CCB 8254
PCN #: DSNO-13APZA934

COMPONENT LOCATION

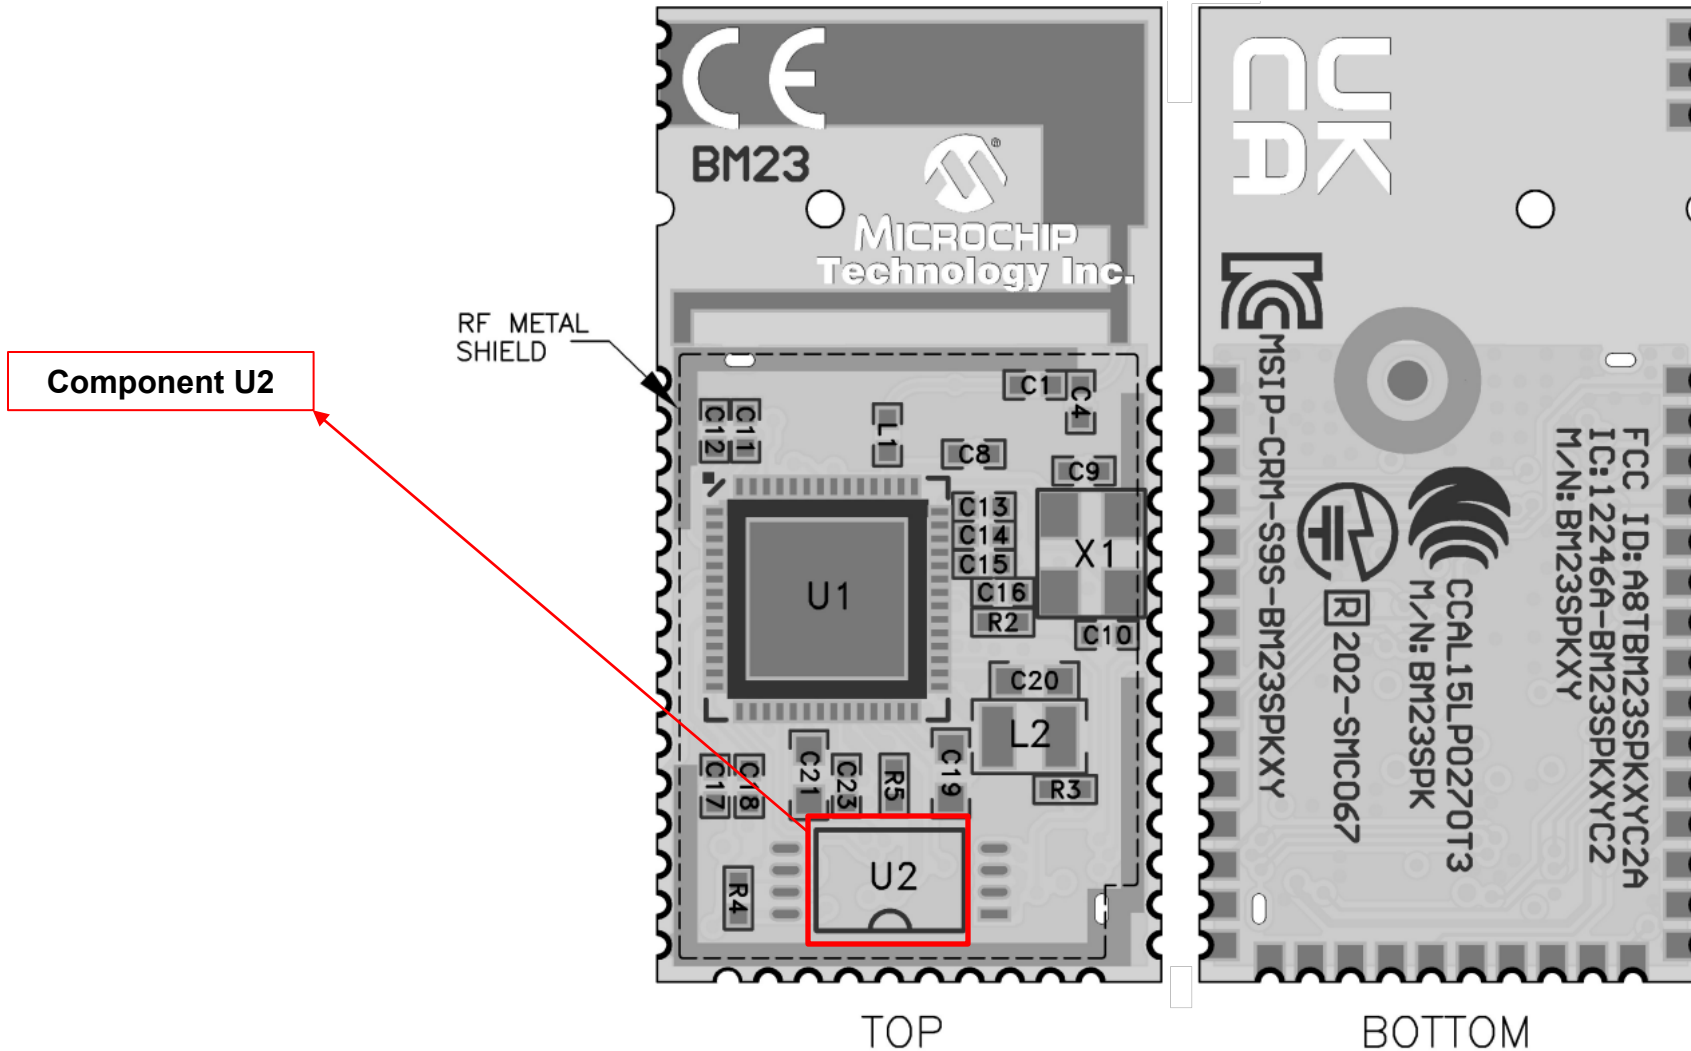
(COMPONENT U2 / AT24C64D-XHM-T)
